FSN Ref: 2026-FSN-000127

URGENT Field Safety Notice

“Purge System Blocked” alarm delay with AIC Old Software version

For Attention of*: Users of Automated Impella Controller (AIC) with software version below 10.1 (Specifically versions 8.2.2 and 8.5) in conjunction with Impella 5.5 first generation (Code 0550-0002)

Figure 1: AIC Software Identification on Example Startup Screen

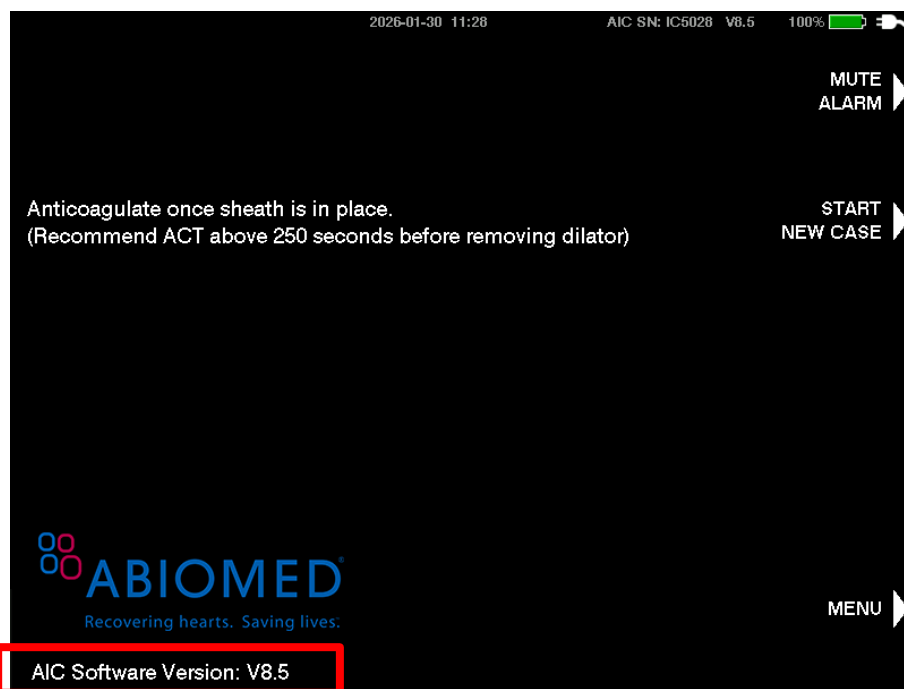
2. Reason for Field Safety Corrective Action (FSCA)*	
2.	1. Description of the product problem* Abiomed has identified that AICs with software version below 10.1 (Specifically versions 8.2.2 and 8.5), when used in conjunction with an Impella 5.5 first generation (product code 0550-002), have a delayed “Purge System Blocked” alarm. Software versions V10.1 or above, and Impella 5.5 second generation (product code: 1000482) have this issue addressed. A review of global complaints from September 1, 2019 to January 16, 2026 found a delay in “Purge System Blocked” alarms in 0.35% of cases. The complaints review determined that there have been no patient deaths attributed to this issue; however, in 10 cases there was a pump / console exchange due to events such as a pump stop or high purge pressure, and it was later determined there was also a delayed “Purge System Blocked” alarm. If the purge flow stops completely, the controller displays the “Purge System Blocked” alarm; see below for an example of the alarm.

- Abiomed recommends that you do not use the AIC with an Impella 5.5 first generation (product code 0550-002) unless AIC software is updated to V10.1 or above.
- AIC software version can be identified in the lower left corner of the initial AIC display screen, see Figure 1 below for example.

- Where required, please contact Abiomed at RA-ABM-EUFieldServic@ITS.JNJ.com to schedule your software update.
- Review, complete all fields, sign, and return the attached Customer Reply Form to DL-EUFSCA@its.jnj.com.
- Forward this notice to anyone in your facility that needs to be informed (i.e., those who manage, transport, store, stock, or use the subject products).
- If any of the subject products have been forwarded to another facility, contact that facility and provide them with this notice.
- Post a copy of this notice in a visible area for awareness.
